## **ADDENDUM NUMBER THREE**

### **YAVAPAI HILLS #1 LIFT STATION REHABILITATION PROJECT**

**DATE OF ADDENDUM: May 13, 2024**

CIP NO. 2105-004  
VOLUME 1 OF 4  
FOR CONSTRUCTION  
ADDENDUM 3

STORAGE BUILDING ENLARGED POWER AND LIGHTING PLANS	
---	--

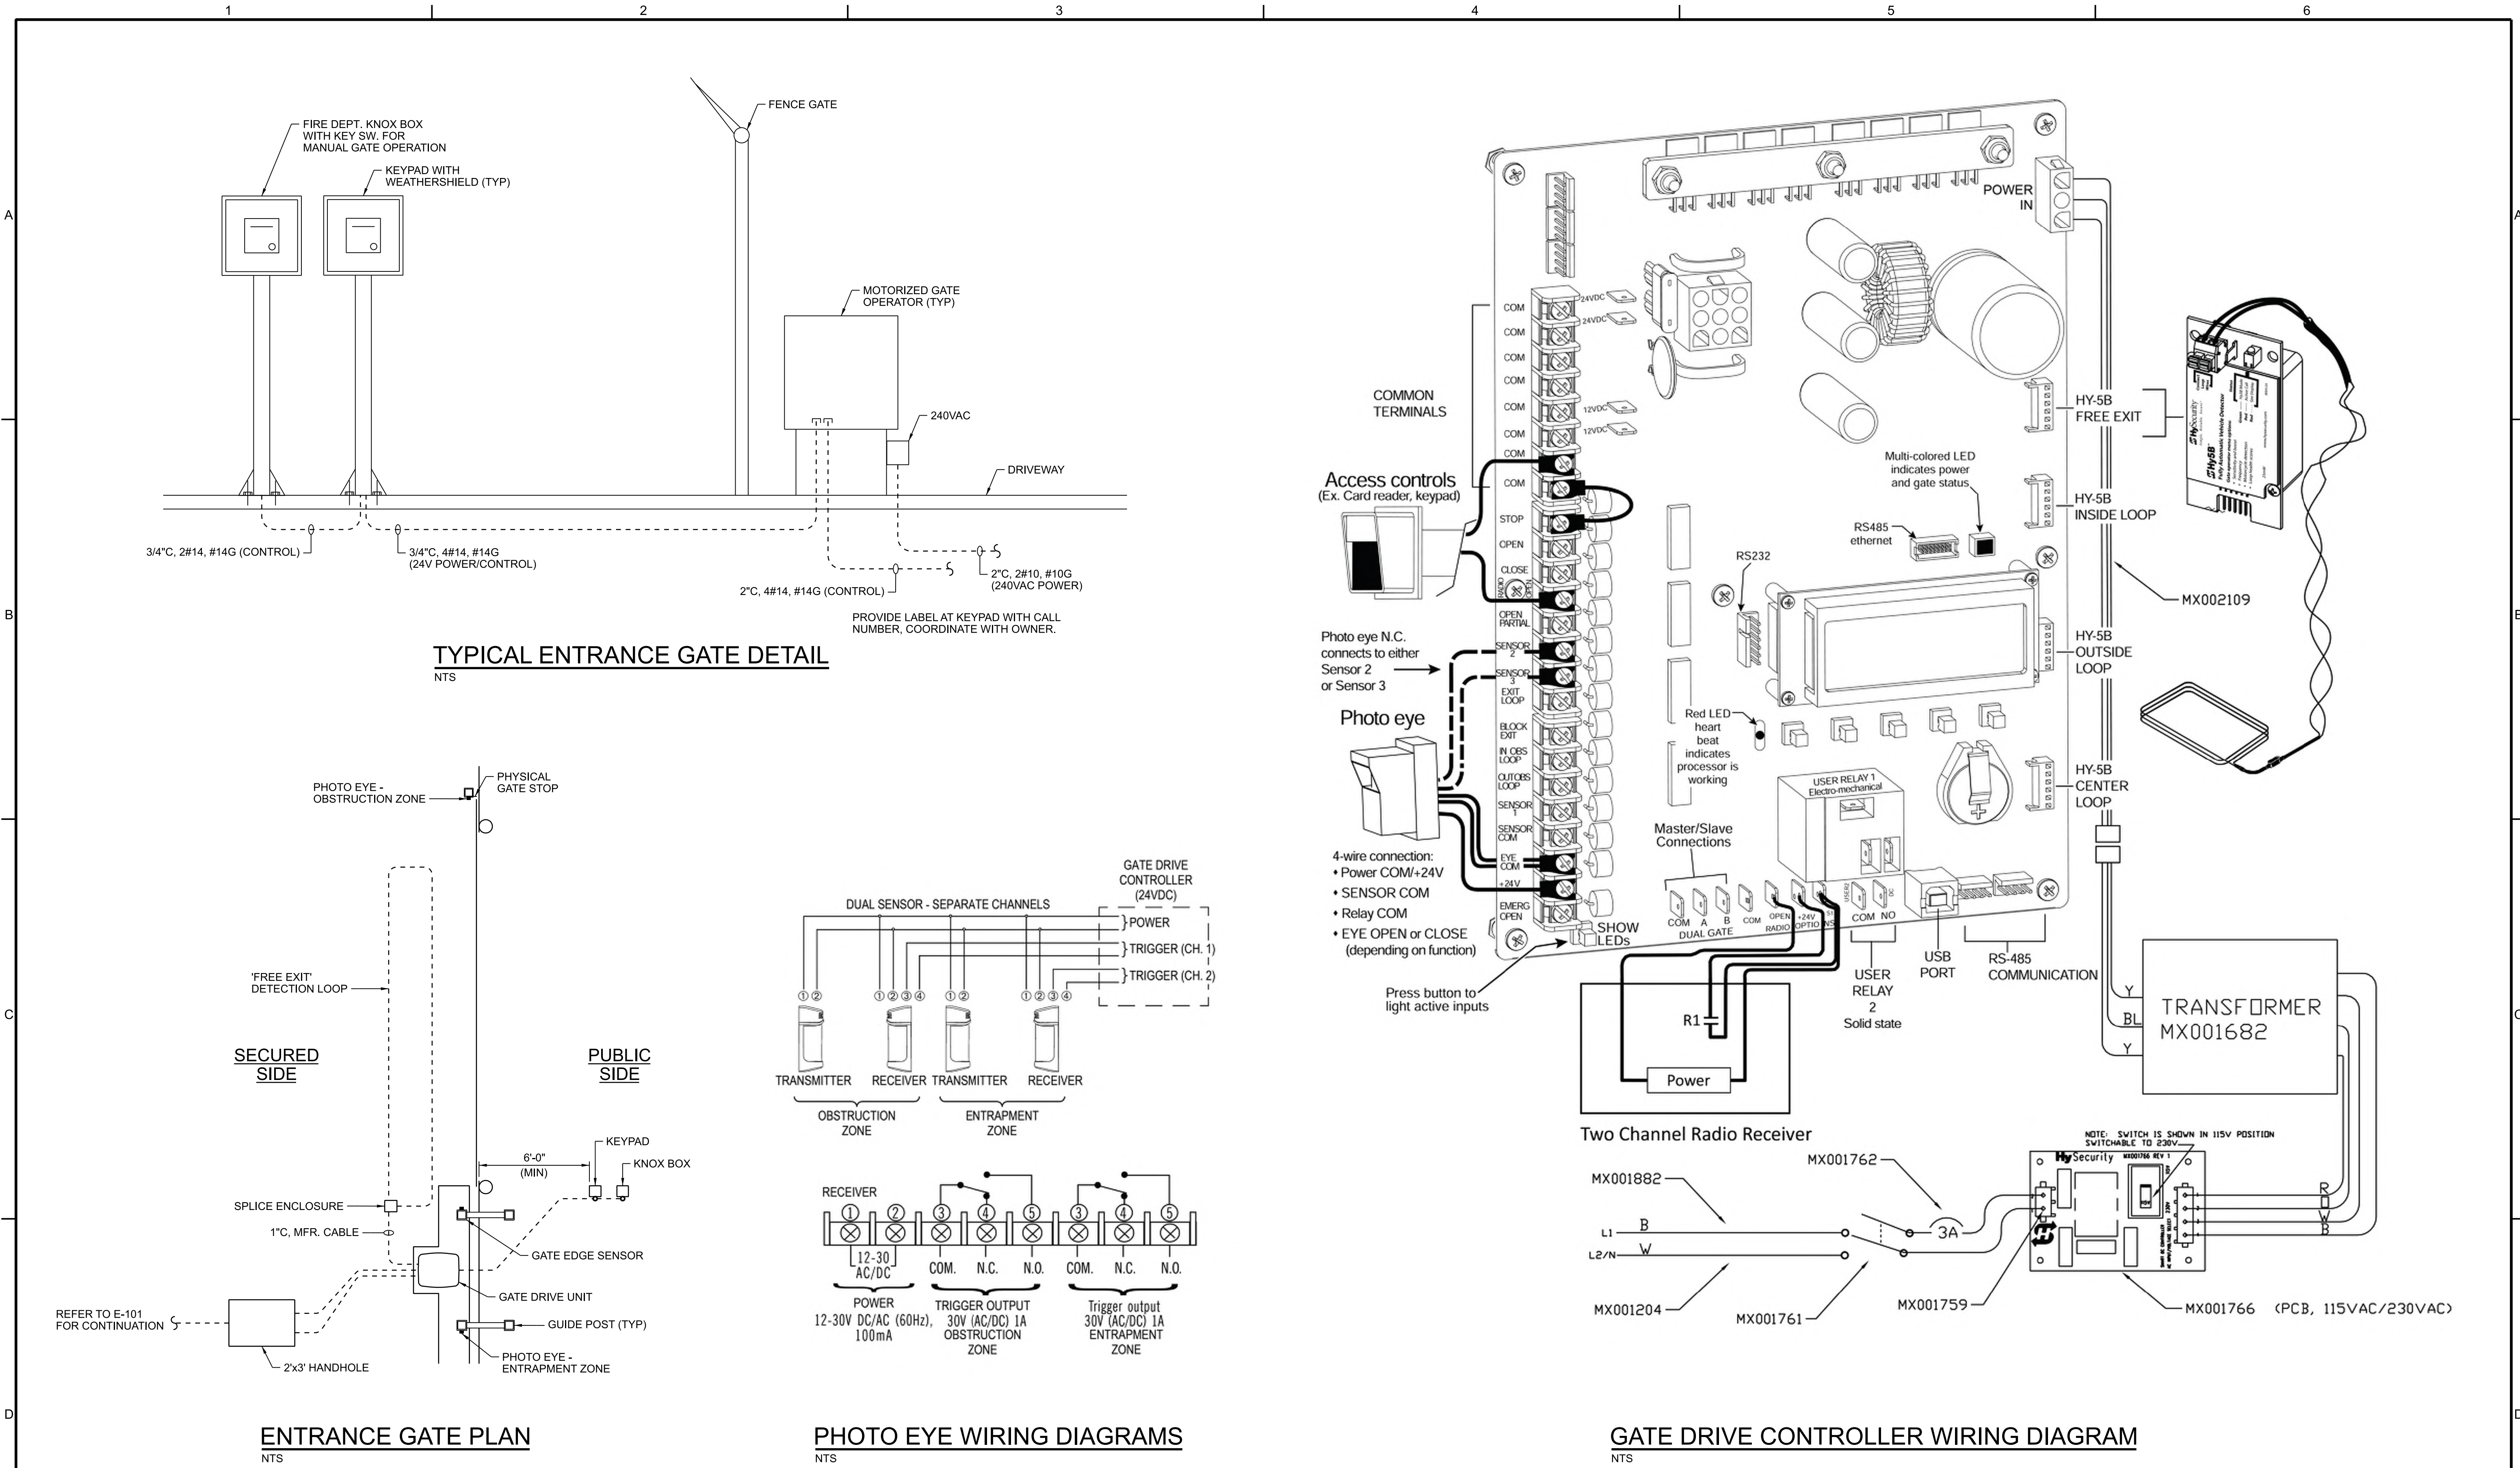
**Question:** The shade canopy shown on C- 101 and E- 102 looks about 26' X 8' in size? Can you provide some details on the height and slope of roof?

**Response:** Slope shall be 0.03 ft/ft. Height shall be coordinated with the final procurement of electrical equipment to be housed under the canopy. At a minimum provide 2' clearance between the top of the equipment and the shade canopy.

2504

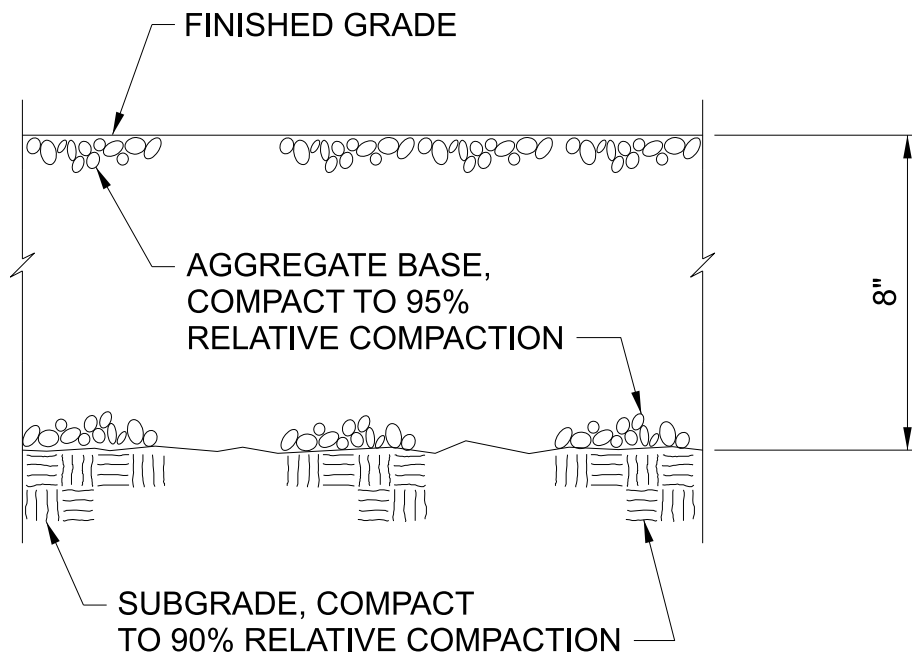
**Question:** On page C- 101 there are gravel designations called out throughout the site. Please provide a detail of what exactly is being asked for by "Gavel".

**Response:** Refer to detail 2504 provided within the standard details book.
